EXPLANATION OF SIGNIFICANT DIFFERENCES MEMORANDUM FOR AIR FORCE PLANT  
4 NAS FORT WORTH TX  
4/10/2007  
AIR FORCE CENTER FOR ENVIRONMENTAL EXCELLENCE

**Air Force Plant 4 Superfund Site  
EPA ID# TX7572024605  
Fort Worth, Tarrant County, Texas**

**FINAL  
EXPLANATION OF SIGNIFICANT DIFFERENCES  
EAST PARKING LOT GROUNDWATER PLUME AND TERRACE  
ALLUVIAL FLOW SYSTEM  
AIR FORCE PLANT 4**

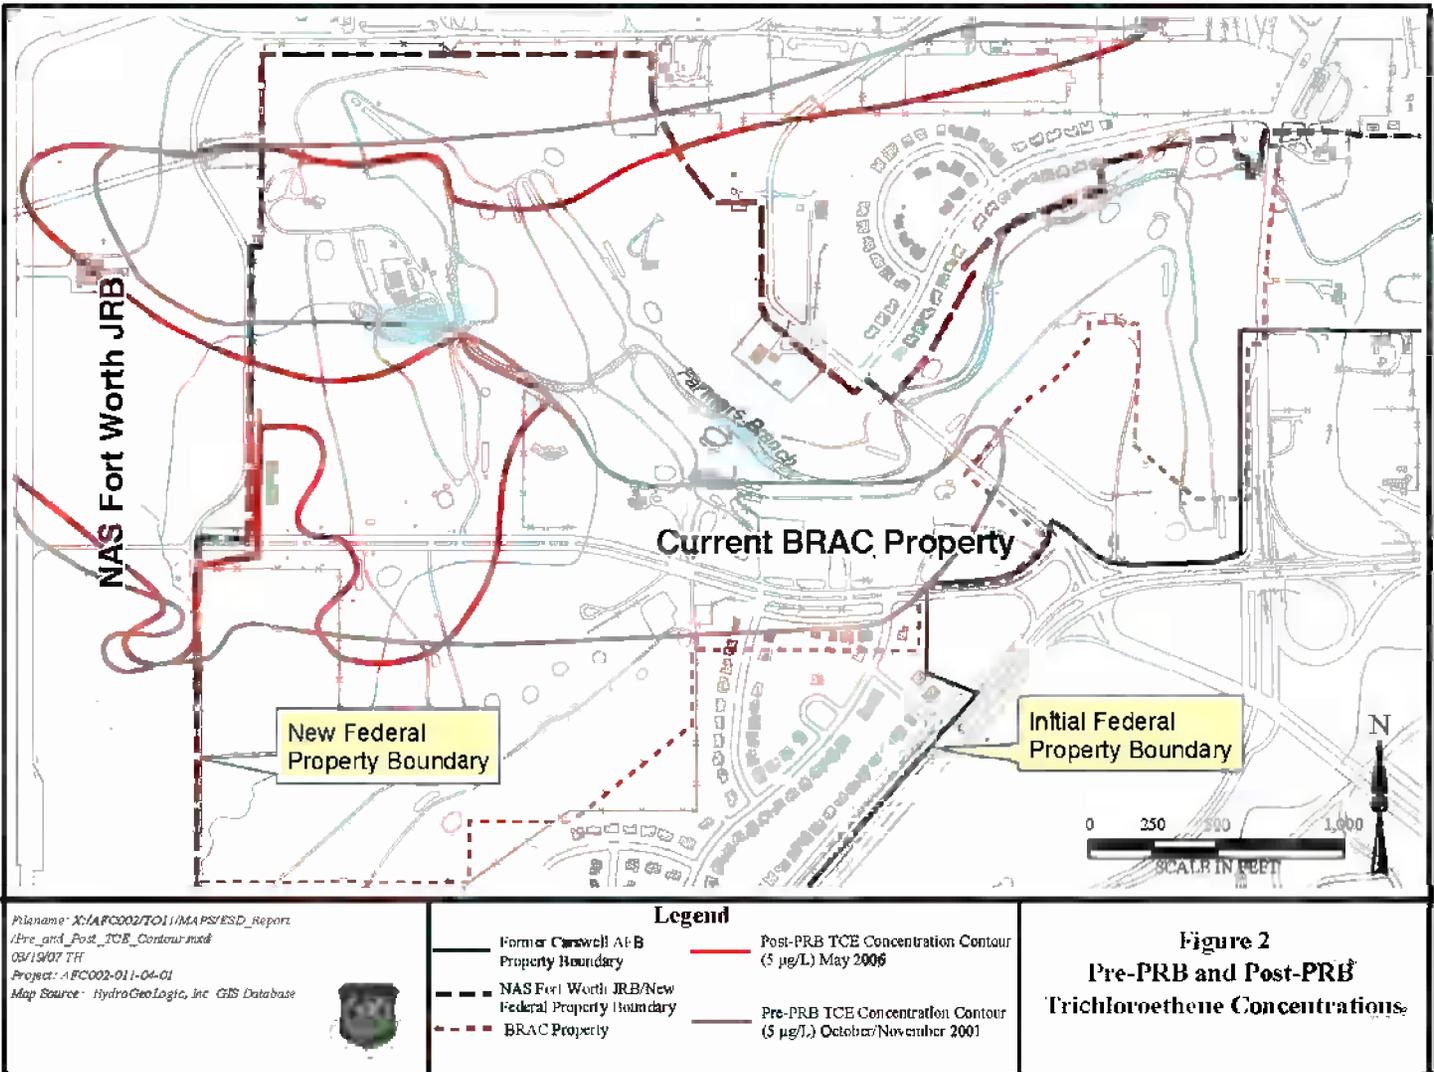
The PRB was designed to treat the TCE in the groundwater that flows through the reactive media onto the BRAC property. Figure 2 presents pre-PRB and post-PRB concentrations for comparison purposes. The performance monitoring data for the PRB indicate that the TCE is also being remediated through microbial activity. An evaluation of pre- and post-PRB data suggests that the microbial populations were stimulated by the use of the guar gum during construction of the PRB. Guar gum was used for liquid shoring (as opposed to a physical shoring method such as sheet-piling) when excavating the PRB.

Post-PRB performance monitoring results show the majority of the PRB achieves a TCE removal efficiency greater than 99% (HGL, 2006a). The PRB does not span the entire TCE plume migrating on to the BRAC property. Where the PRB does not intersect the plume, the PRB has no effect on contaminant concentrations. Because the PRB was installed along the BRAC/NAS Fort Worth JRB property boundary, most of the contamination already present on the BRAC property was cut off from the remainder of the plume extending from AFP 4. Monitoring data indicate that groundwater treated by the PRB is flushing residual contamination downgradient of the PRB. In the area immediately downgradient of the PRB, modeling presented in the OPS Demonstration Report estimated that the TCE MCL will be achieved in 3.6 years. In areas further downgradient of the PRB and in the portions of the BRAC property plume not affected by the PRB, but being treated through MNA, it was estimated that TCE contamination will achieve the MCL in approximately 30 years (HGL, 2006b).

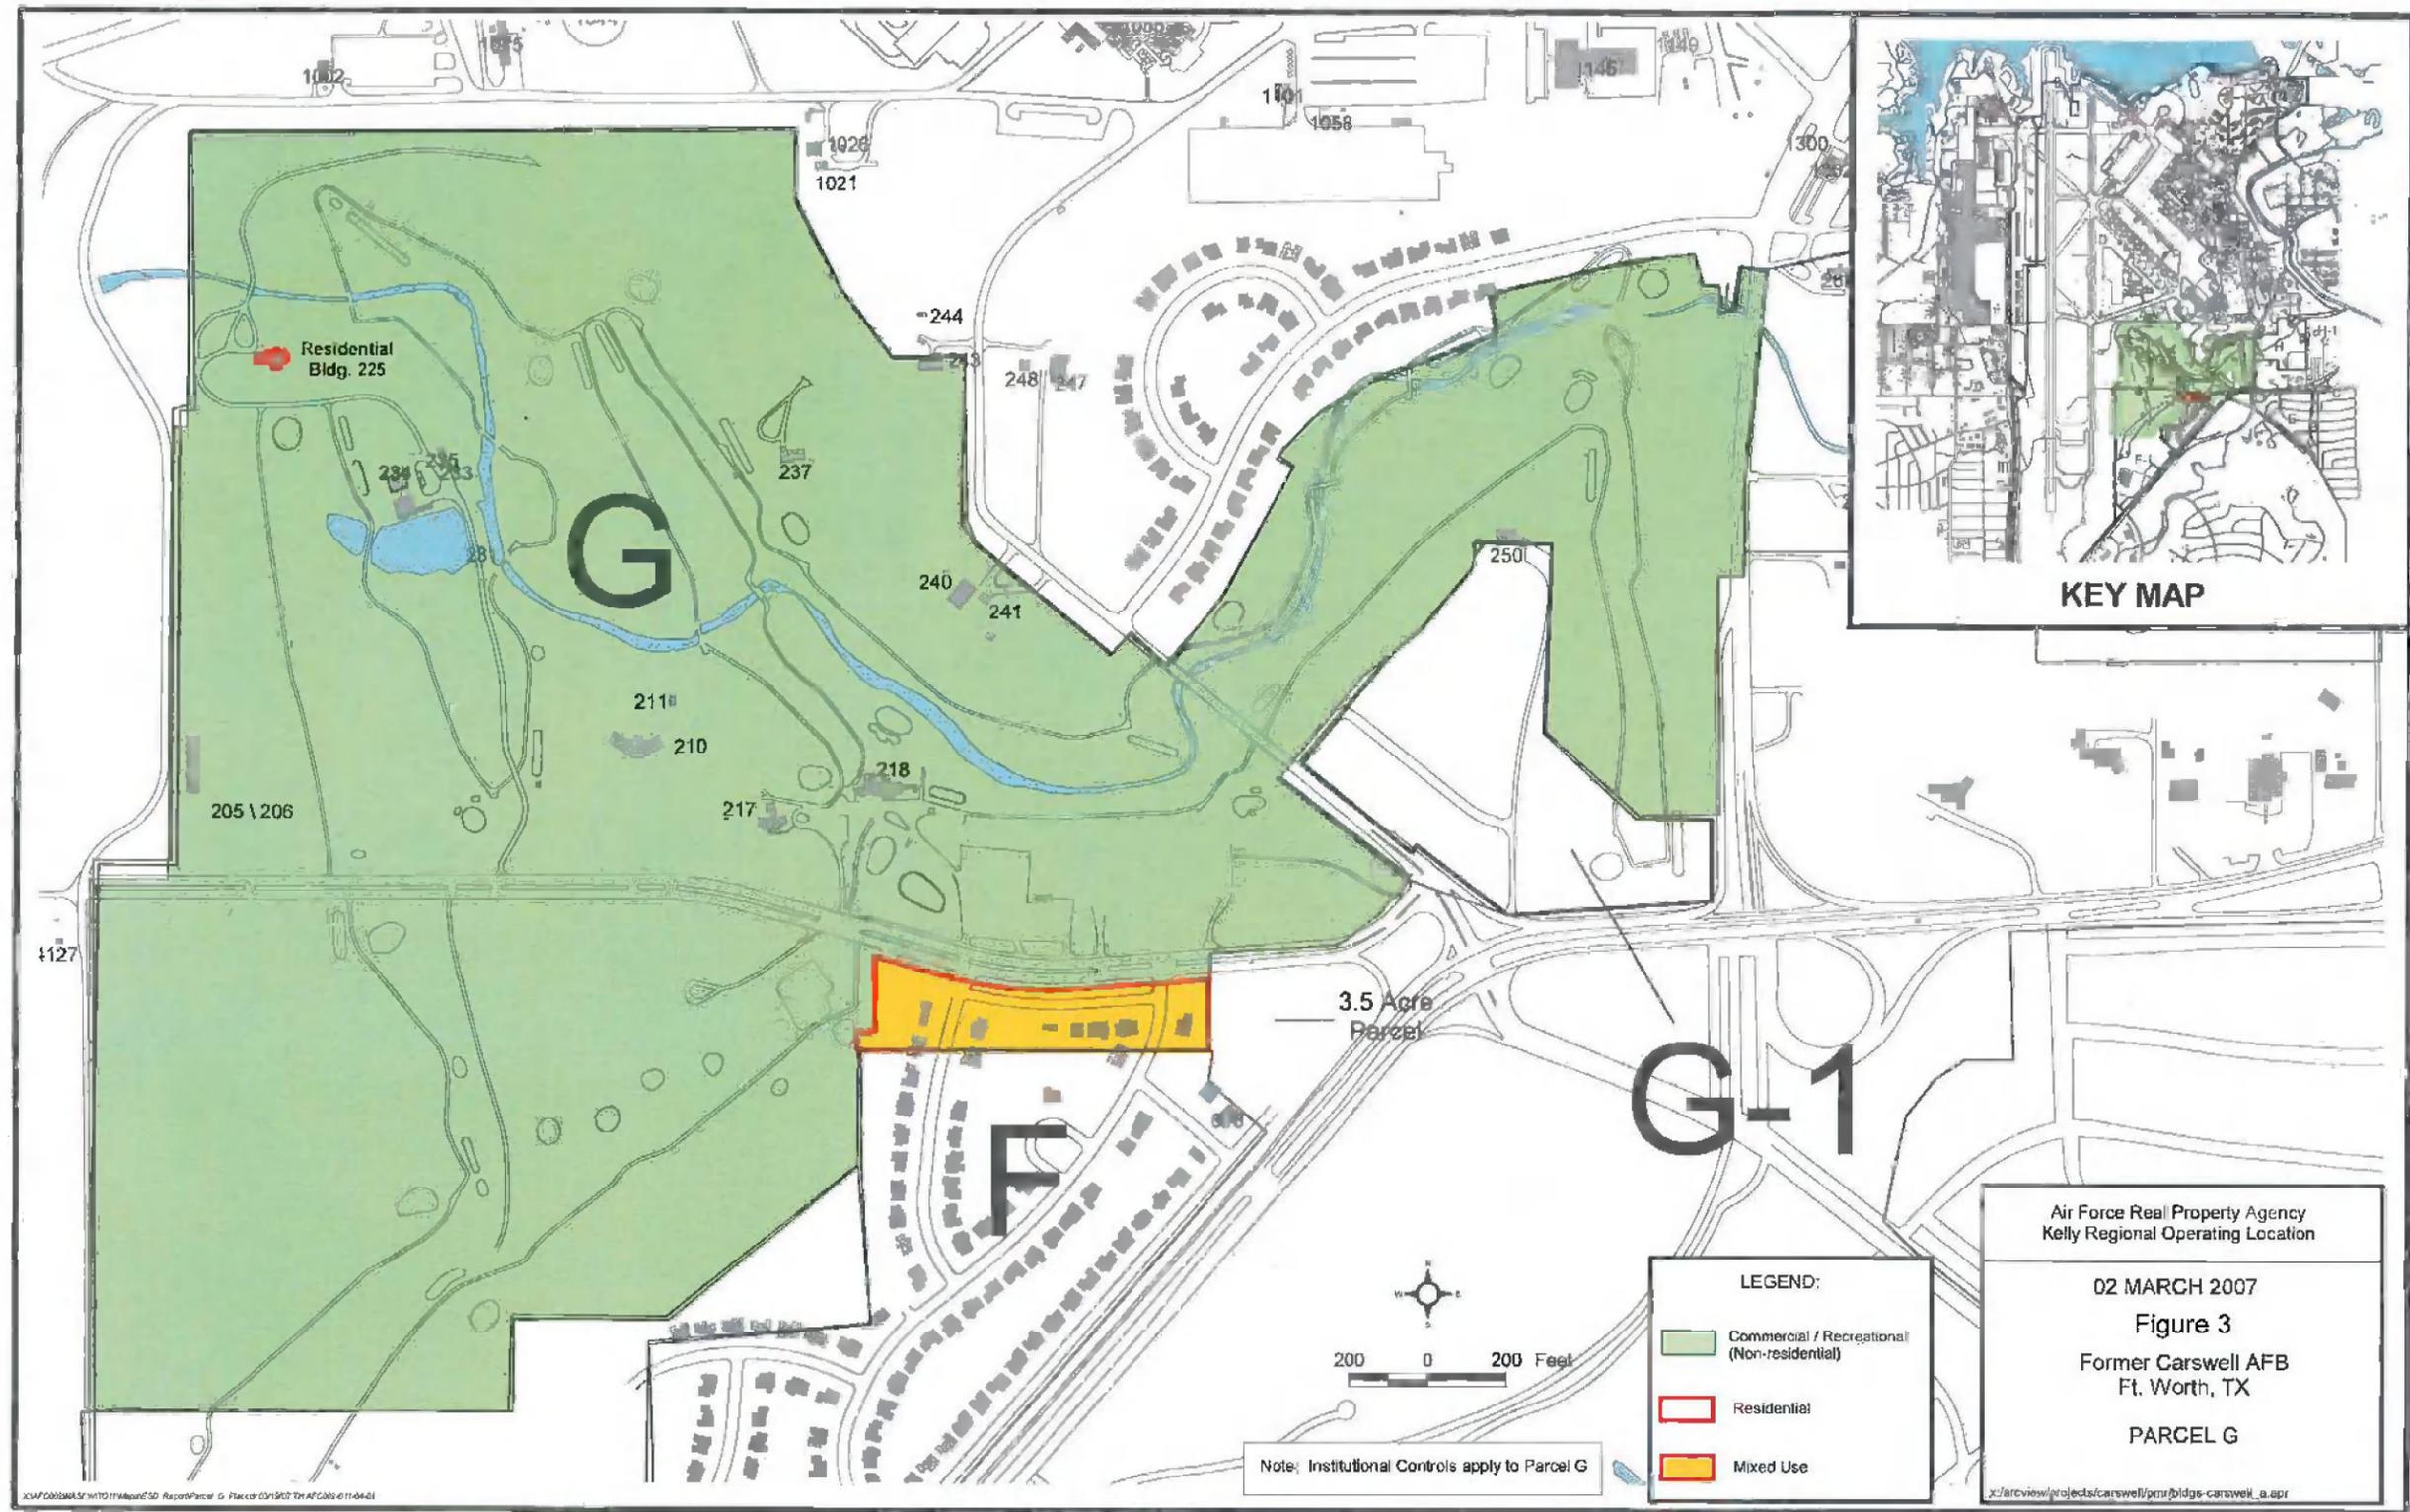
- a) The 187-acre parcel is restricted to non-residential use only except as shown in Figure 3;
- b) Digging/excavation is restricted:
  - at the PRB location as well as the surrounding 25-foot buffer zone to protect its integrity (Figure 4), and
  - in shallow groundwater areas where exposure by a construction worker in a trench may cause unacceptable risks;
- c) The integrity of the monitoring wells, including recirculation wells, must be protected and maintained; and
- d) Groundwater cannot be used except for monitoring and/or treatment.

Figure 3 - Proposed Extent of ERH Remediation

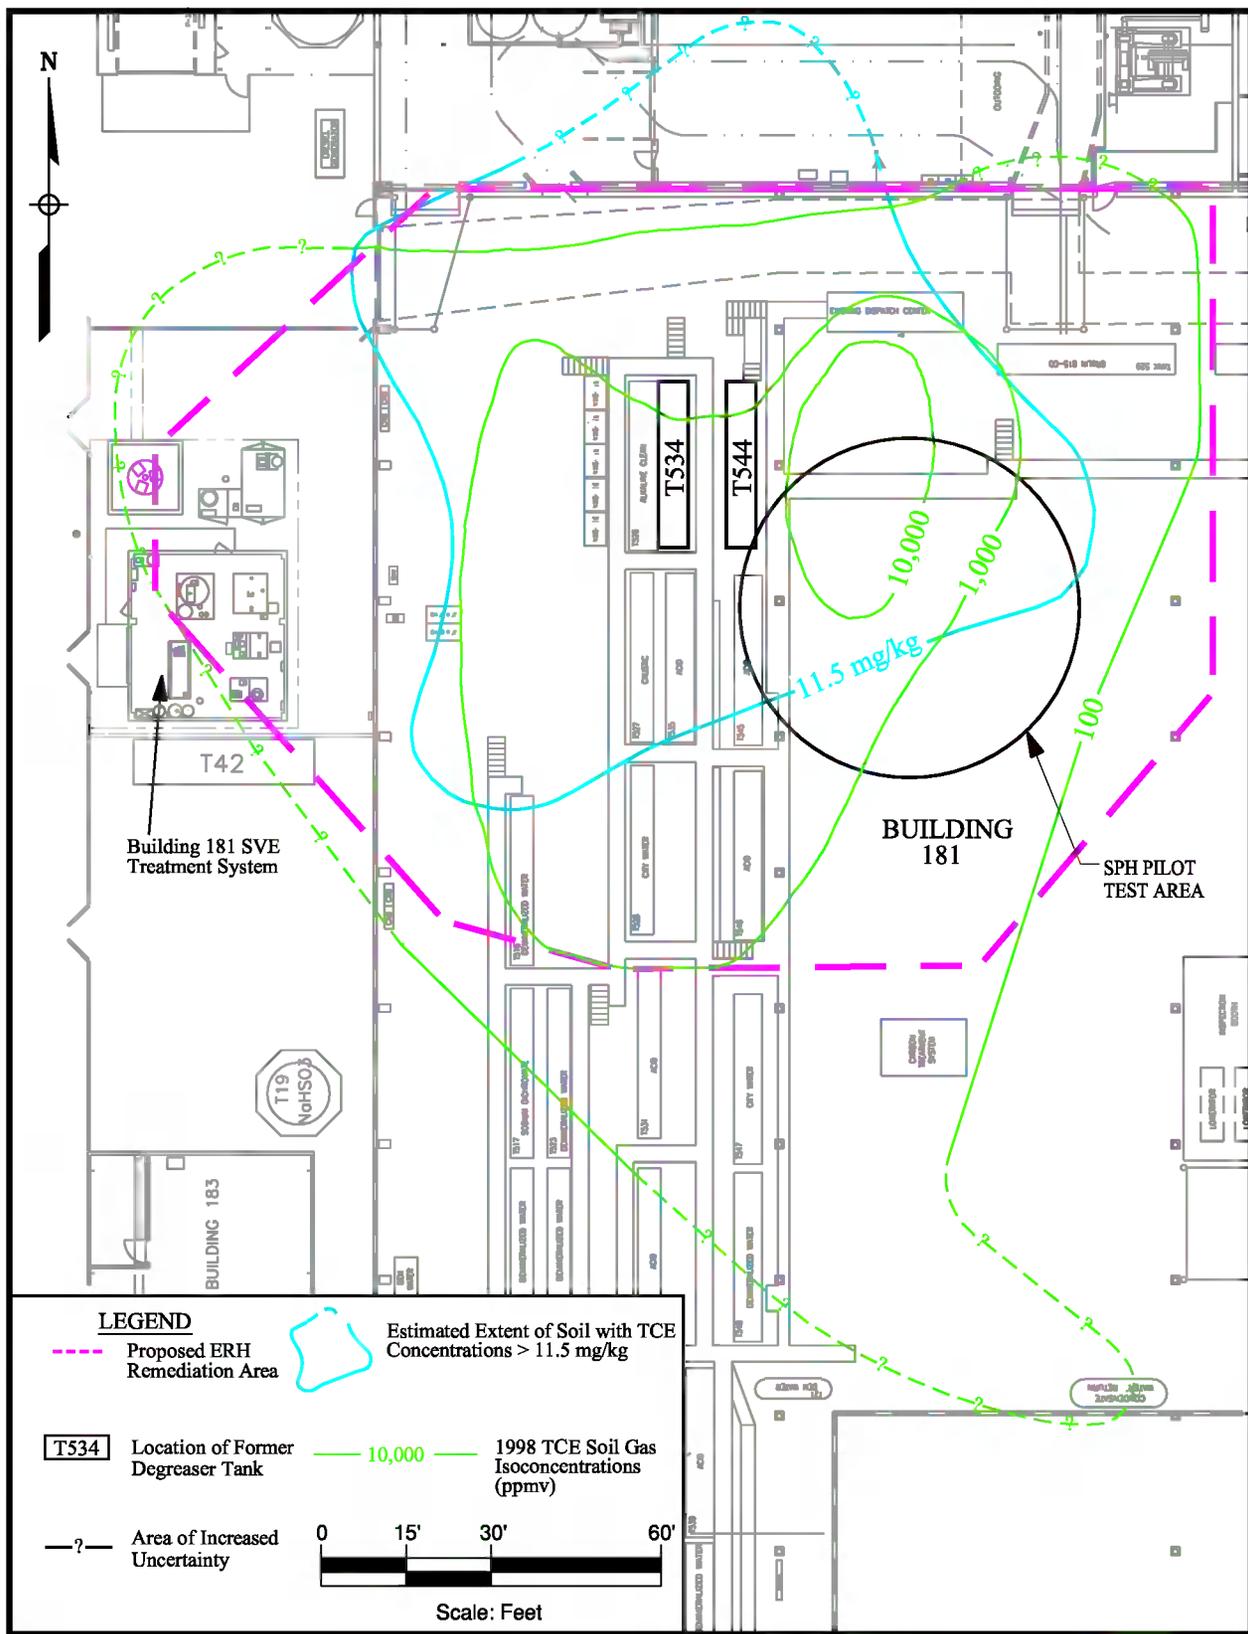
The current understanding is that DNAPL is *not* present everywhere TCE concentrations are greater than 10 mg/L, but instead may be limited to the “source” area within Building 181 (an approximately ½-acre area) where historical spills/leaks from degreasing operations occurred. With source area groundwater concentrations of TCE typically over 100 mg/L, dilution/dispersion processes alone could readily account for the current down-gradient expanse of the TCE plume with concentrations greater than 10 mg/L. Therefore, the ERH remediation will be focused on source reduction in the ½-acre area of verified soil and groundwater contamination greater than the RAOs for these media. The remaining dissolved phase groundwater plume with TCE concentrations less than 10 mg/L will be monitored to verify decreasing concentrations with source reduction, or possibly addressed with a less aggressive remedial approach in the future. The existing EPL groundwater extraction and treatment system should intercept the downgradient dissolved phase plume and ensure that ROD remediation goals are **Figure 3** shows the proposed ERH application area in Building 181. Also shown are the plan view extents of: 1) the area of soil contamination beneath Building 181 with TCE concentrations greater

than 11.5 mg/kg, and 2) soil gas TCE isoconcentration contours. The locations of the removed degreaser tanks T-544 and T-534, believed to be the source of the TCE contamination, are included on the figure as well.

Because the lateral extents of elevated TCE concentrations in the soil and soil gas (which forms the basis for the ERH application area) are estimated in some locations, the ERH electrode placements will be flexible along the perimeter of the proposed application area. Additional boreholes will be drilled outside the proposed extent of remediation, and soil samples screened for volatile organic compound levels, to help determine whether the remediation area needs expanding and ensure that heating encompasses all unsaturated zone source material.
